The Calcutta Gazette

APPENDIX.

NOTICES TO MARINERS.

The following Notices are republished for general information.

Chart affected.—No. 3717, Plan of the River Mersey.

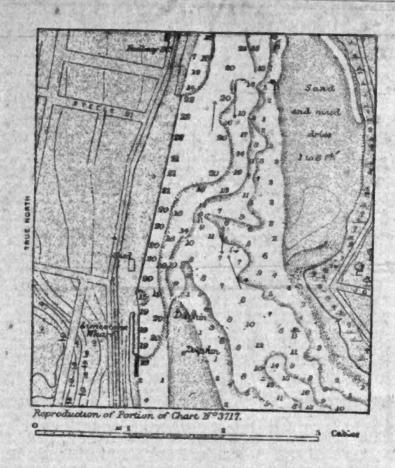
Details.—The accompanying reproductions of portions of the plan of the River Mersey on chart No. 3717 show the necessary corrections to that plan with regard to depths, the positions of dolphins, &c., and new wharfs which have been constructed at West Devonport.

Remarks.—It will be seen from the reproductions that the depth in the entrance channel has decreased.

Charts affected .- No. 3114, Moji and Shimonoseki ko.

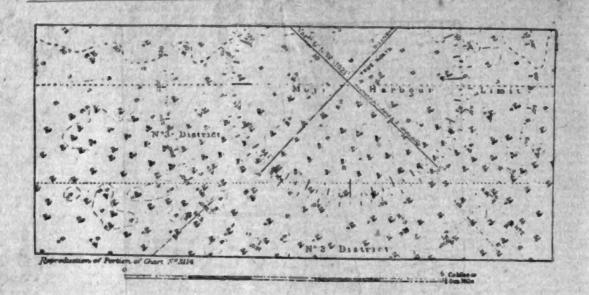
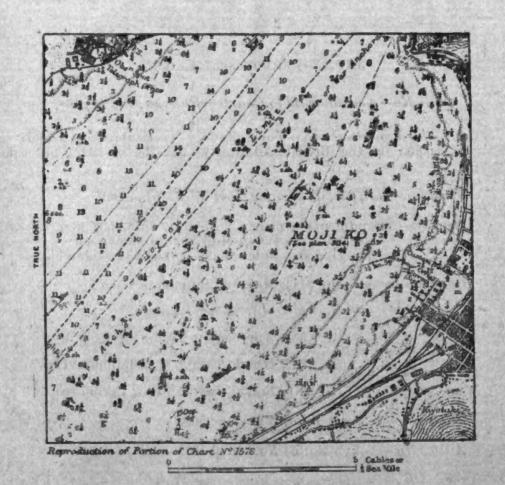
Details.—Amendments to charts Nos. 3114, 1578, 532 and 127 with regard to depths in Moji ko are shown on the accompanying reproductions of portions of those charts.

Charl affected.—No. 1701, Plans of Tarusan bay and Tabekat bay. Publication.—China Sea Pilot, Vol. I., 1916, pages 387, 454, 455.

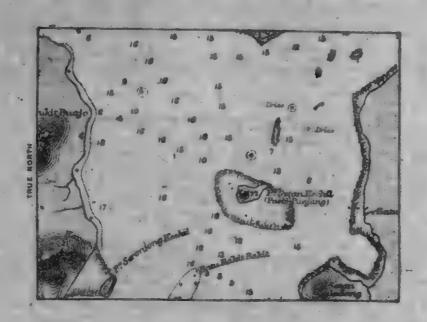
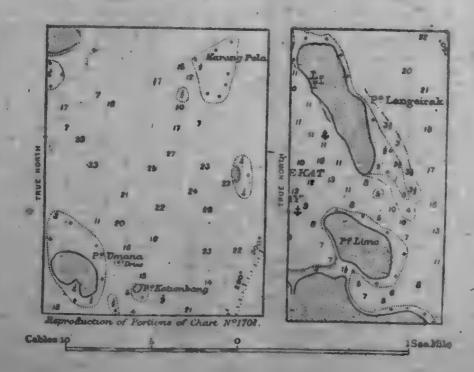
Position .- Pulo Setan Kechil, lat. 1° 13' S., long. 100° 25' E. (approx. Details.—The accompanying reproduction of a portion of the plan of Tarusan bay on chart No. 1701 shows the necessary corrections to that plan with regard to rocks and shoals in the vicinity of Pulo Setan Kechil.

Details.—The accompanying reproduction of portions of the plan of Tabekat bay on chart No. 1701 shows the necessary corrections to that plan with regard to reefs and shoals in the approaches to Tabekat bay.

Note.—From the reproduction it will be observed that the alternative names of certain islands have been omitted.

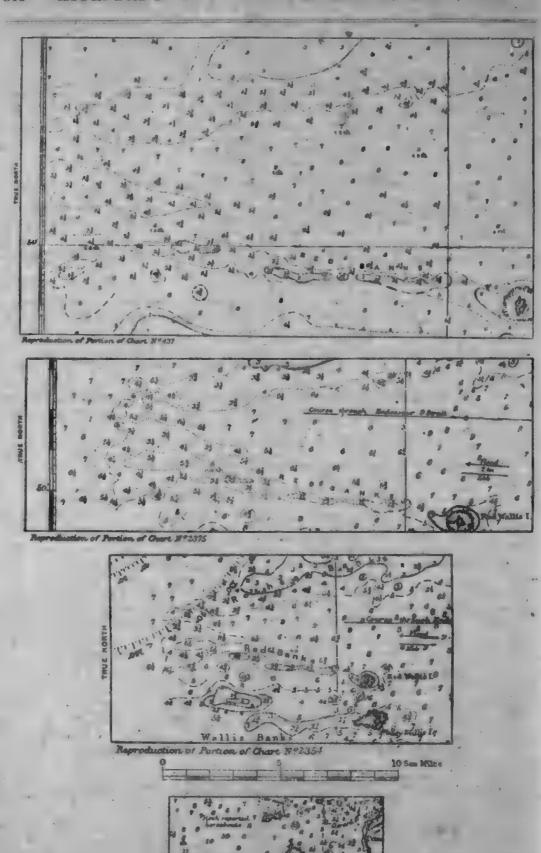
> Details.—The accompanying reproductions of portions of charts Nos. 437, 2375, 2354, 447 show the amended depths south-westward and southward of Rothsay banks in the western approach to Endeavour strait, as a result of a recent survey.

Charts affected.—No. 2597, Banka strait.
,, 2149, Banka and Gaspar straits.
,, 941a, Eastern Archipelago—sheet 1.

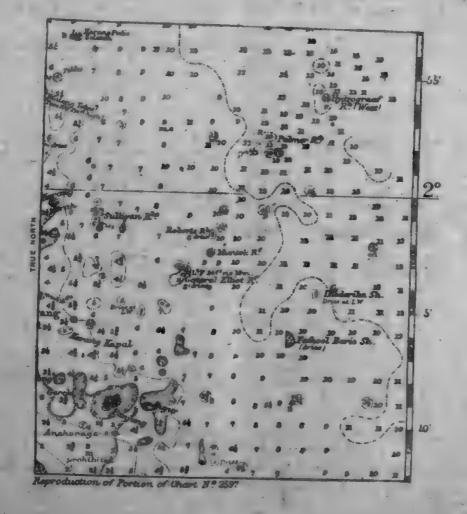
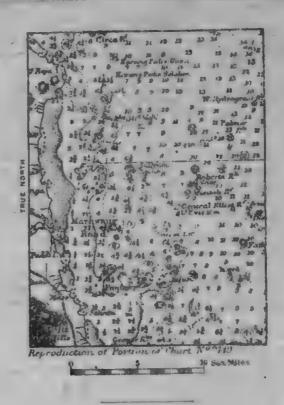
> Details.—The accompanying reproductions of portions of charts Nos. 2597, 2149 show the necessary amendments with regard to shoals and depths in the approaches to Marawang road.

Charts affected.—No. 901, Suakin harbour.

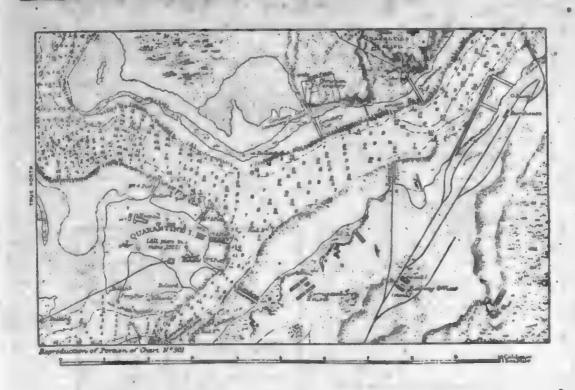
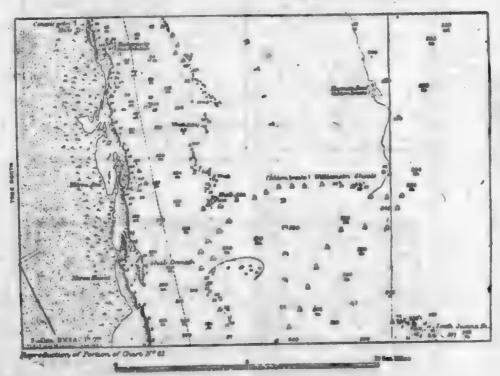
Details.—The following note is to be inserted under the name "Shab ul Shubuk" on the chart.

"In the Northern Entrance to the Channel West of Shab ul Shubuk the least depth available is 3\fathoms 1922."

Charts affected .- No. 3616, Tomori gulf to Salayar strait.

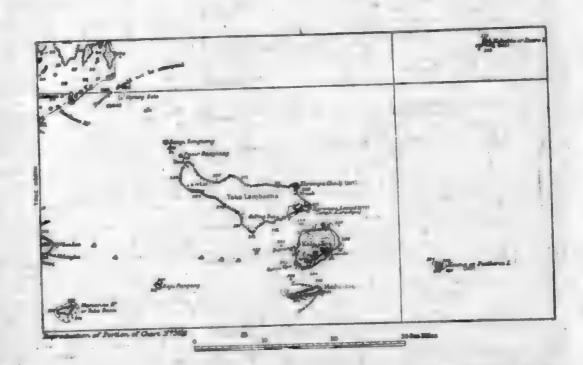
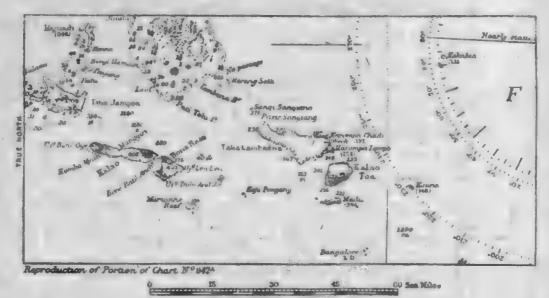
Details.—The accompanying reproductions of portions of charts Nos. 3616, 941b, 942a, 2759a, show the necessary amendments to the charts in the Flores sea, south-east of Pulo Salayar.

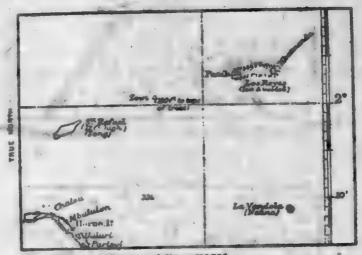
Details.—The accompanying reproduction of portions of charts

Nos. 769 and 2766 shows the necessary amendments to
the charts with regard to the positions of La Vandola (Nauna) and San Rafael (Toug) islands, also the height of the trees on Towi island.

Chart affected .- No. 1100, Plan of Iwo jima.

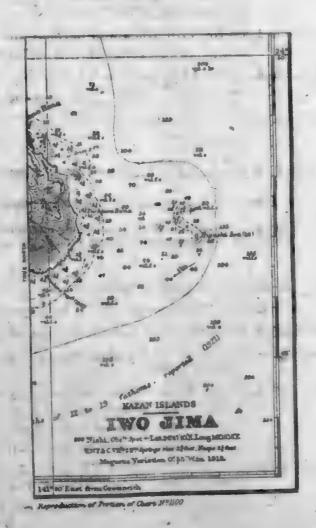
Details.—The accompanying reproduction of a portion of the plan of Iwo jima on chart No. 1100 shows the necessary corrections to that plan with regard to a shoal extending north-westward from Higashi iwa and depths in the vicinity.

Note.—It will be observed that the note with regard to rocks and breakers reported between Iwo jima and Higashi iwa has been omitted from the reproduction.

Chart affected.—No. 1701, Plans of Tarusan bay and Tabekat bay.

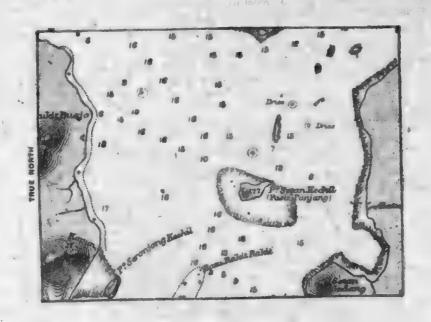
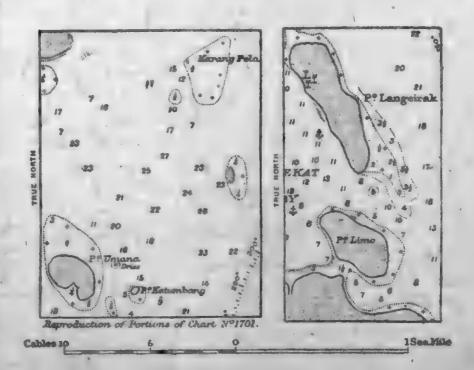
Position.—Pulo Setan Kechil, lat. 1° 13' S., long, 100° 25' E. (approx. Details .- The accompanying reproduction of a portion of the plan of Tarusan bay on chart No. 1701 shows the necessary corrections to that plan with regard to rocks and shoals in the vicinity of Pulo Setan Kechil.

Details.—The accompanying reproduction of portions of the plan of Tabekat bay on chart No. 1701 shows the necessary corrections to that plan with regard to reefs and shoals in the approaches to Tabekat bay.

Charts affected.—No. 437, Albany pass to Booby island.

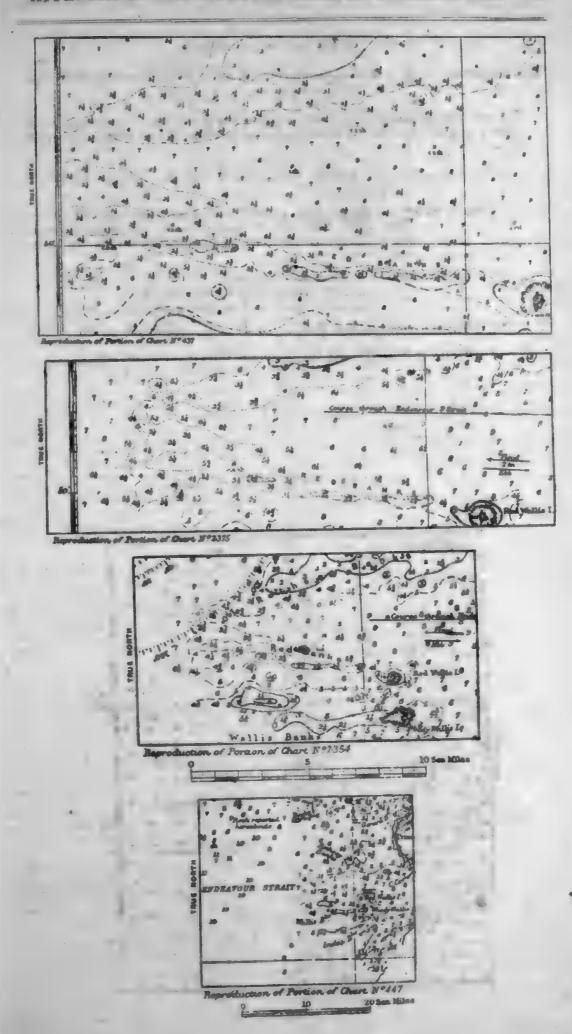
Details.—The accompanying reproductions of portions of charte Nos. 437, 2375, 2354, 447 show the amended depths south-westward and southward of Rothsay banks in the western approach to Endeavour strait, as a result of recent survey.

Charts affected.—No. 2597. Banka strait.
,, 2149. Banka and Gaspar straits.
,, 941a, Eastern Archipelago—sheet 1.

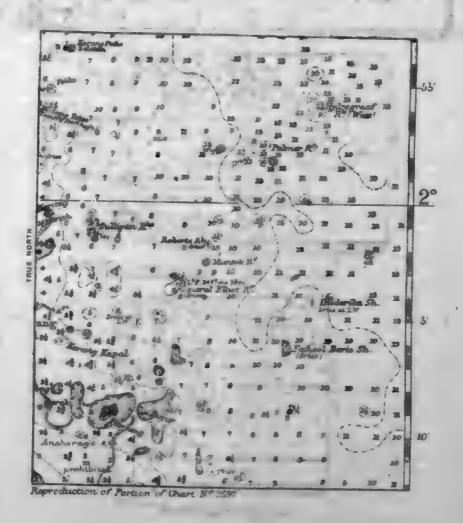
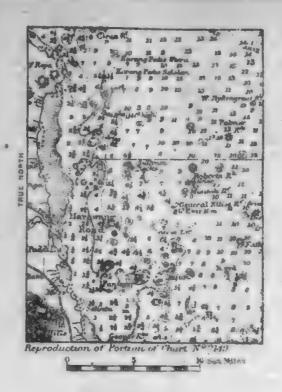
Details.—The accompanying reproductions of portions of charts Nos. 2597, 2149 show the necessary amendments with regard to shoals and depths in the approaches to Marawang road.

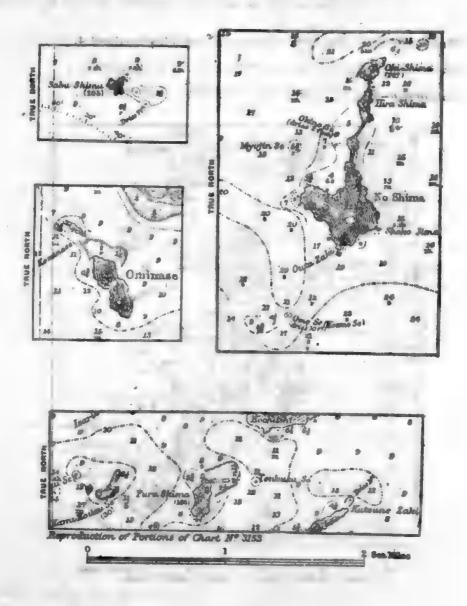
• Details.—The accompanying reproduction of portions of charts
Nos. 3153 and 2875 show the necessary amendments with
regard to sheals and depths off the northern shore of the
Suwo nada.

Charts affected .- No. 3616, Tomori gulf to Salayar strait.

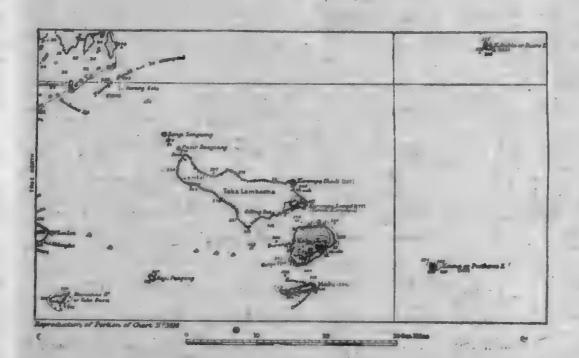
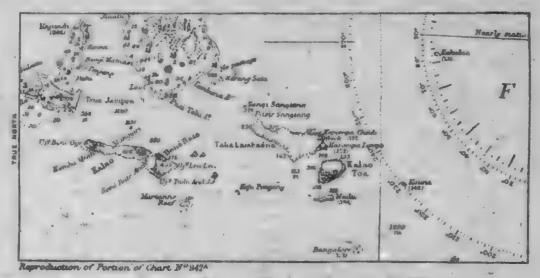
Details.—The accompanying reproductions of portions of charts Nos. 3616, 941b, 942a, 2759a, show the necessary amendments to the charts in the Flores sea, south-east of Pulo Salayar.
